Architectural Response to DCC LRD Opinion
SVRD-STW-XX-XX-RP-A-022004

This report comprises an Architectural response to the Planning Report on Recommended Opinion (LRD 6009/22).

Exerpt from Site Sections 13 - See SVRD-STW-ZZ-ZZ-DR-A-025007 - Section through Building F and the Northern Boundary

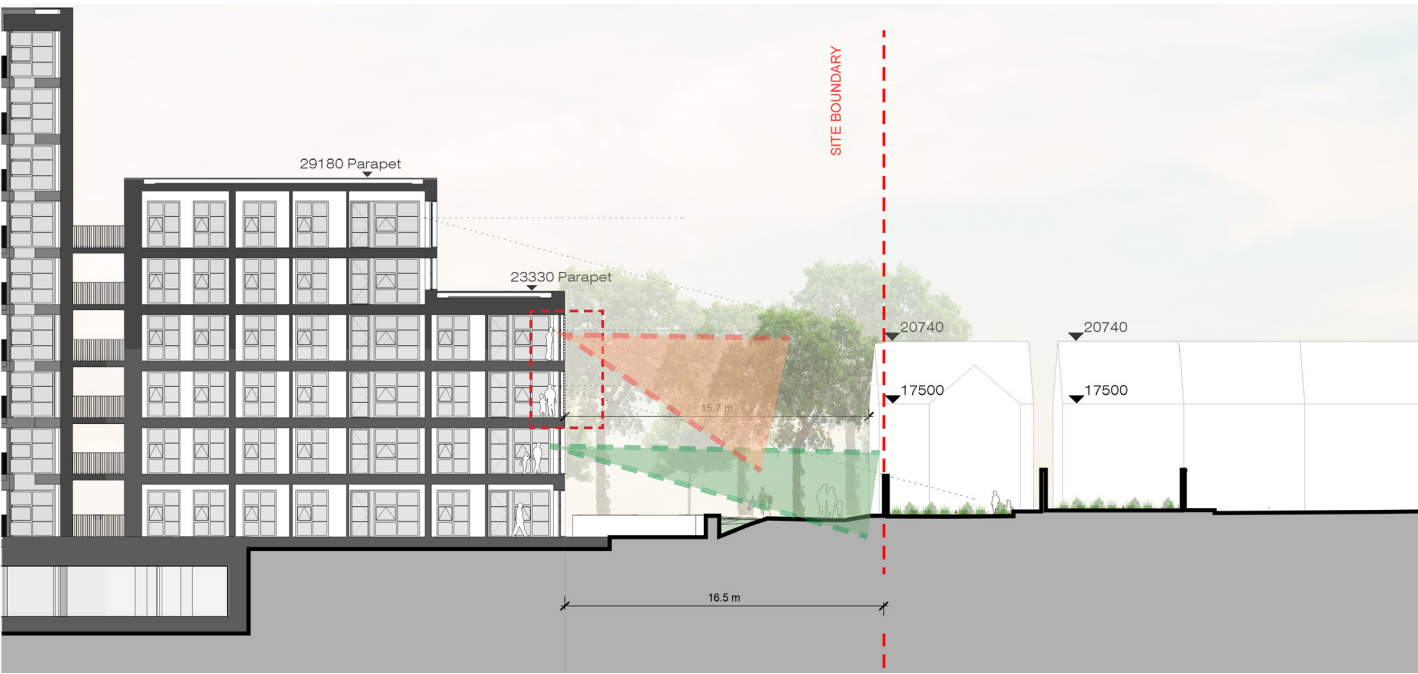
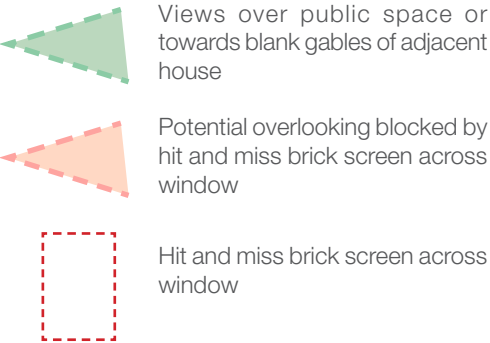
a) ‘Demonstration that neighbouring amenity is not unduly affected in terms of overlooking or overbearing impact particularly to the north of the site and to the southwest of the site. That the proposal accords with Section 15.9.18 ‘Overlooking and Overbearance’.

- Building F is the closest to the Northern boundary and adjacent houses, and steps down to 4 stories as it approaches the activity trail along the boundary.
- On due consideration and bearing in mind the DCC LRD Opinion, we have reduced the northern section of the building by a full floor, reducing the height from 10 to 9 storeys, significantly reducing the visual impact of the building on the neighbouring development.
- In this re-evaluation of the massing of Building F, it was considered that the northern 4 and 6-storey elements were appropriately scaled with respect to the neighbouring development and did not present an overbearing aspect - as illustrated in the sections on this page.

The 10th storey which was proposed in the LRD Pre-Application Submission has been removed to reduce any potential overbearance in relation to the existing neighbouring residential development to the north

‘Shadow gap’ detail between lift core and existing eaves

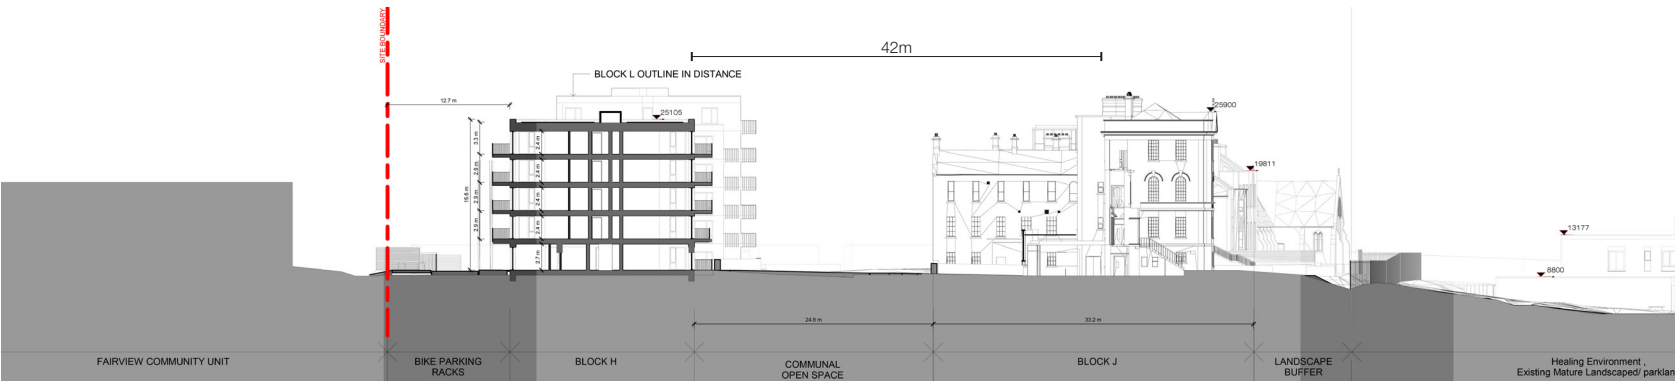
5.5 ‘New buildings adjacent to the protected structures are subordinate in height/scale (below eaves of the PS)’

All new buildings immediately adjacent to the protected structures are subordinate in height/scale (below eaves). See the elevations on this page showing that the proposed building J sits below the eaves of the existing building.

The only exception to this is the new lift core - shown in the centre of the North Elevation - which is required to provide full accessibility to all levels of the existing structure. In this situation the part of this core that touches the existing structure is set below the level of the eaves. See image below.

Excerpt from Detailed Basement Bike Stores SVRD-STW-CP-B1-DR-A-02702

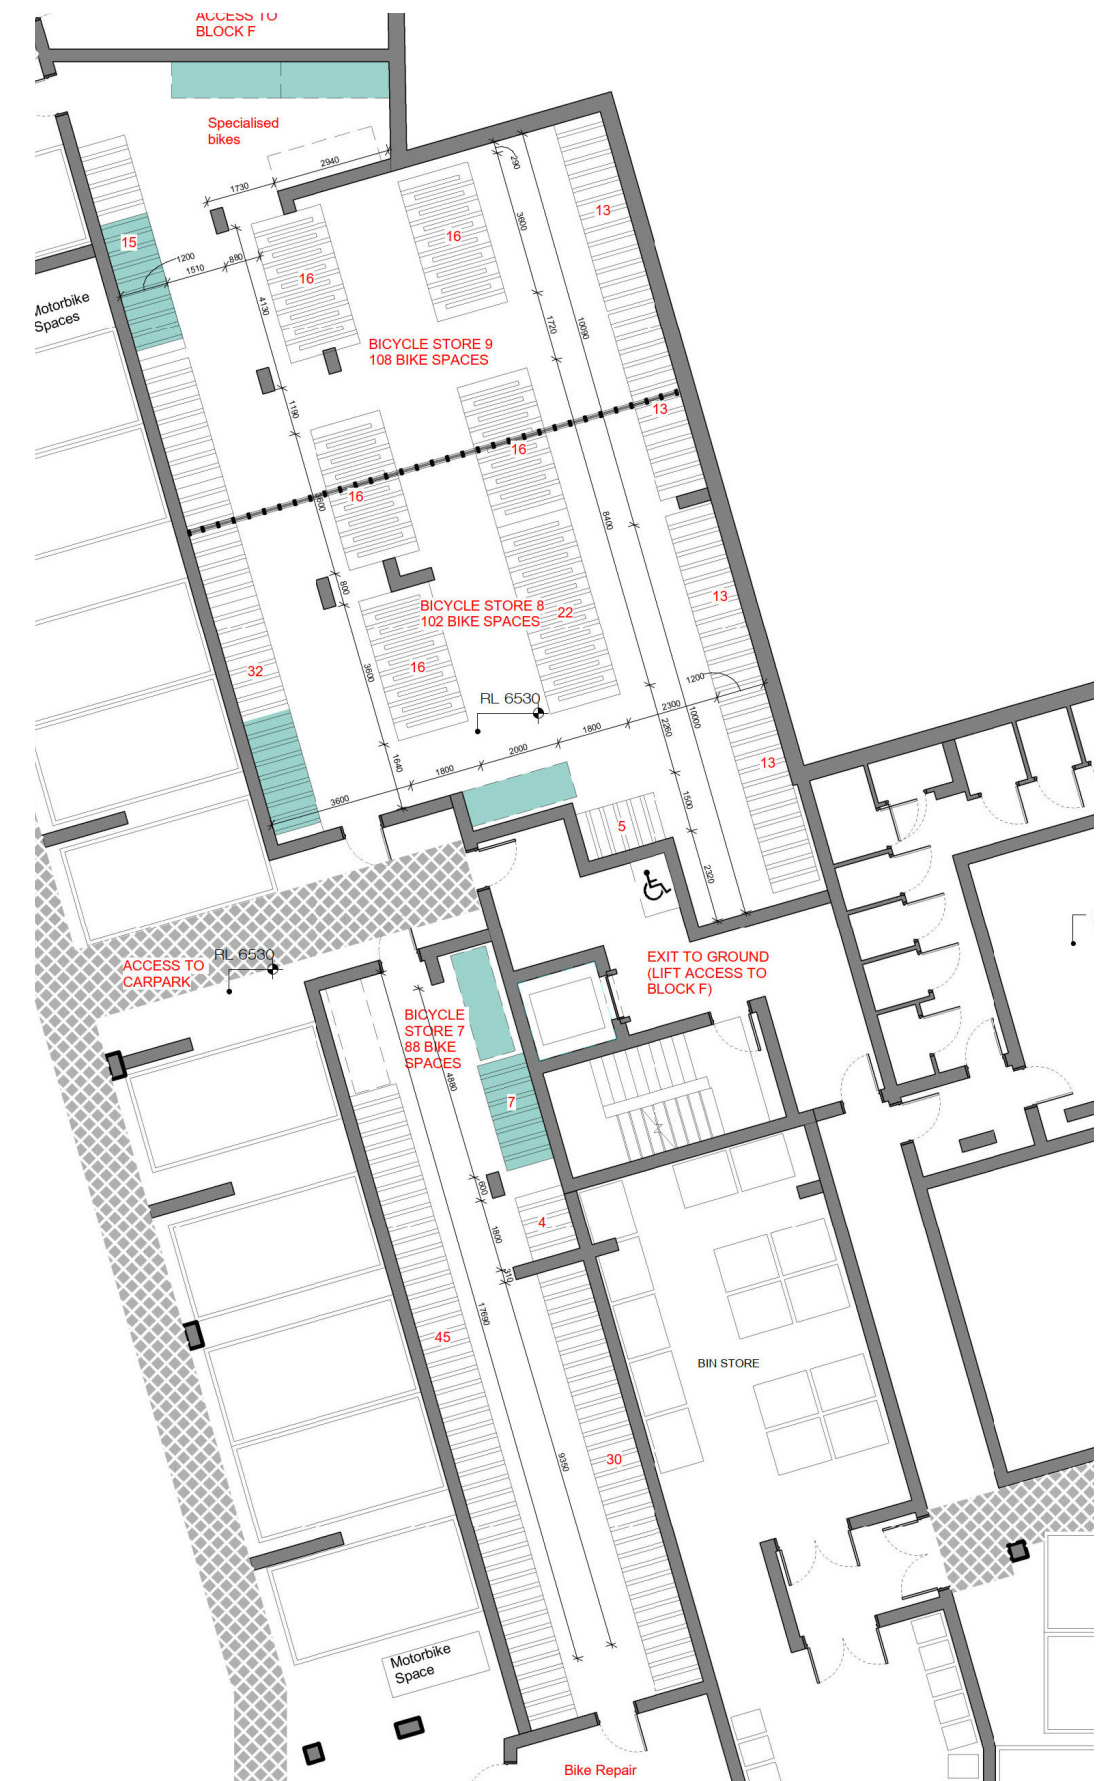
i. Details on how cyclists are to access the cycle stores at basement level should be clearly delineated/identified. If access is via the basement entrance along with other vehicles, additional user safety measures should be demonstrated including demarcated pedestrian/cyclist route, surface marking/signage, lighting and height clearance (min 2.6m) to avoid vehicular and pedestrian conflict.

ii. Detailed drawings of the bicycle stores to be provided outlining type and quantum per store/area, ensuring functionality and ease of access, including the type of bicycle stands proposed and distance between each stand. Ensure bicycle stores are located at the most convenient areas close to stairs/lifts in the basement area. Ensure the access doors to these stores are appropriately located.

i. Details on how cyclists are to access the cycle stores at basement level are clearly delineated/identified. Access is via the basement entrance along with other vehicles and additional user safety measures are demonstrated including demarcated pedestrian/cyclist route, surface marking/signage, lighting and height clearance (min 2.6m) to avoid vehicular and pedestrian conflict.

ii. Detailed drawings of the bicycle stores are provided. All bicycle stores are located at the most convenient areas close to stairs/lifts in the basement area and access doors to these stores are appropriately located. See Basement GA Plan SVRD-STW-CP-B1-DR-A-022001 and detailed store layouts SVRD-STW-CP-B1-DR-A-027001 and SVRD-STW-CP-B1-DR-A-027002.

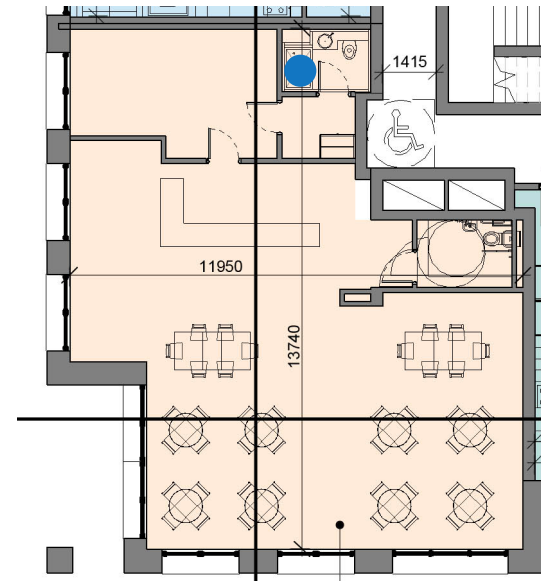
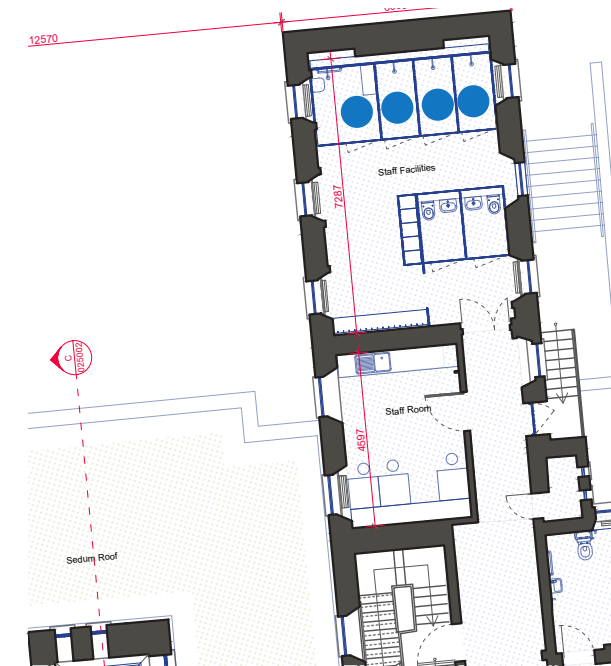
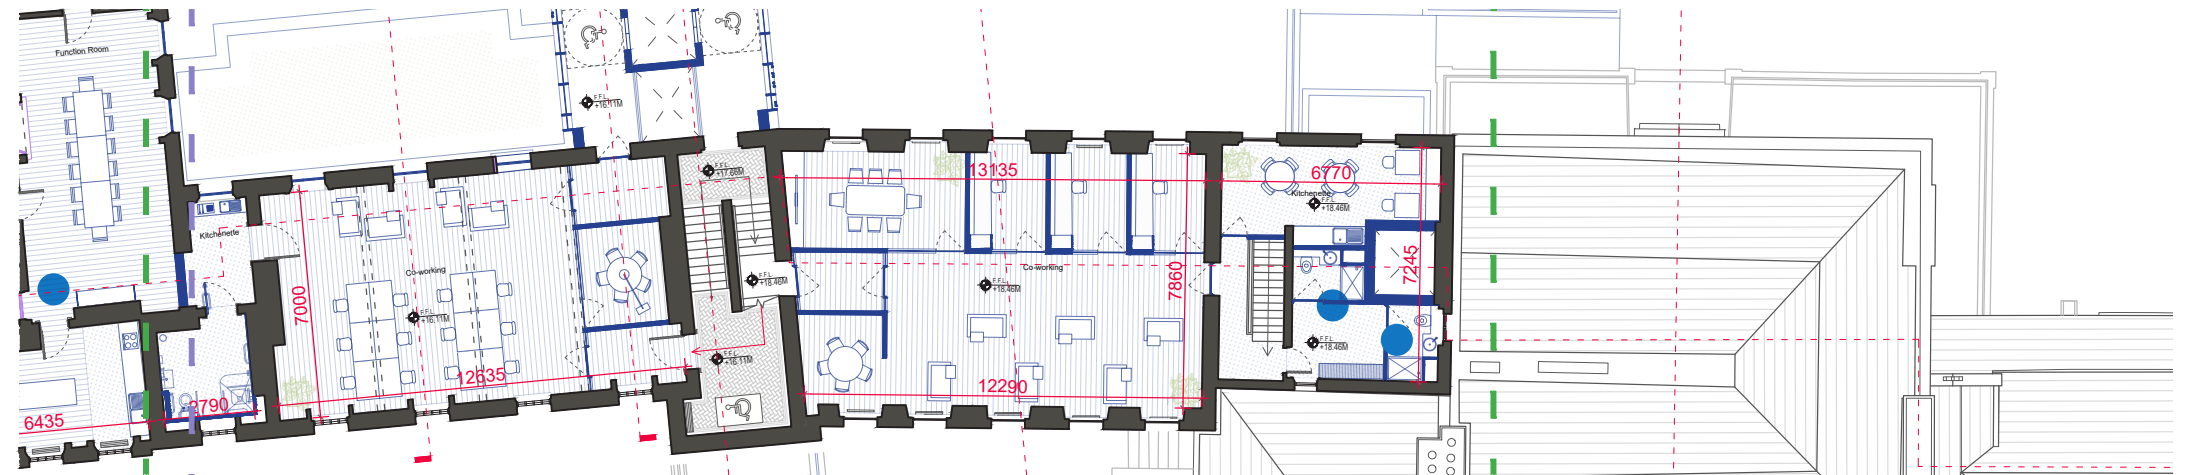
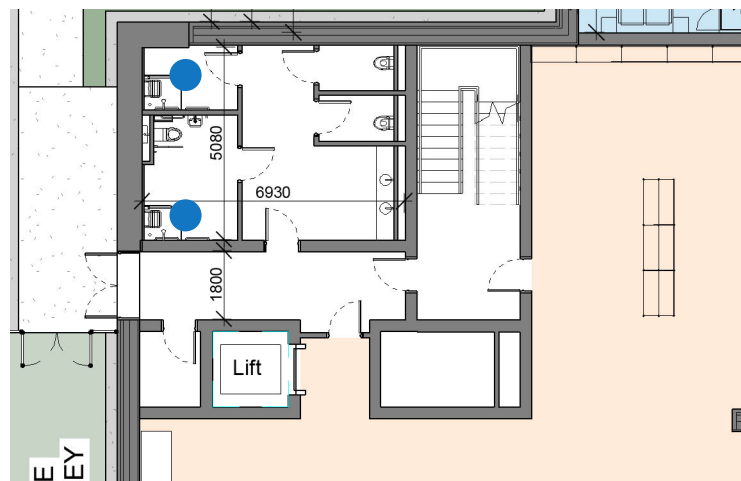
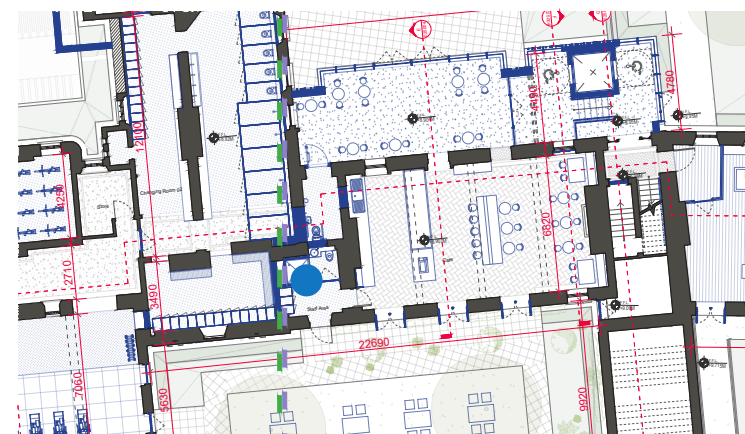
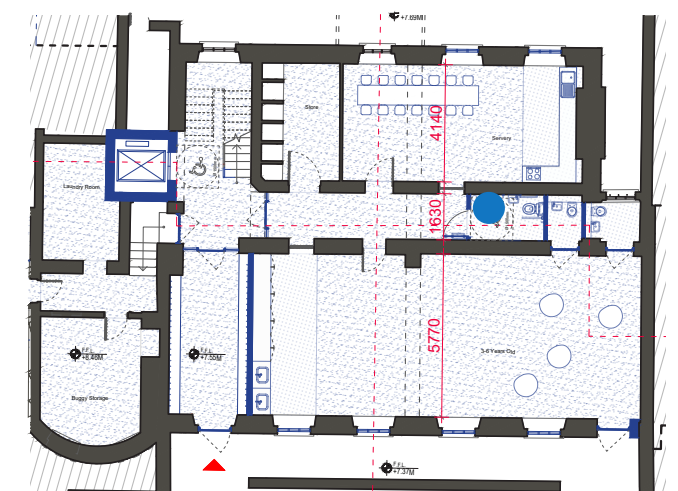
vii. Showers and changing facilities for the commercial use buildings should be provided.

for Commercial development:
 min 1 shower per commercial space > 75 sq.m
 min 2 showers per commercial space >500 sq.m
 plus 1 additional shower per every 1000sq.m thereafter
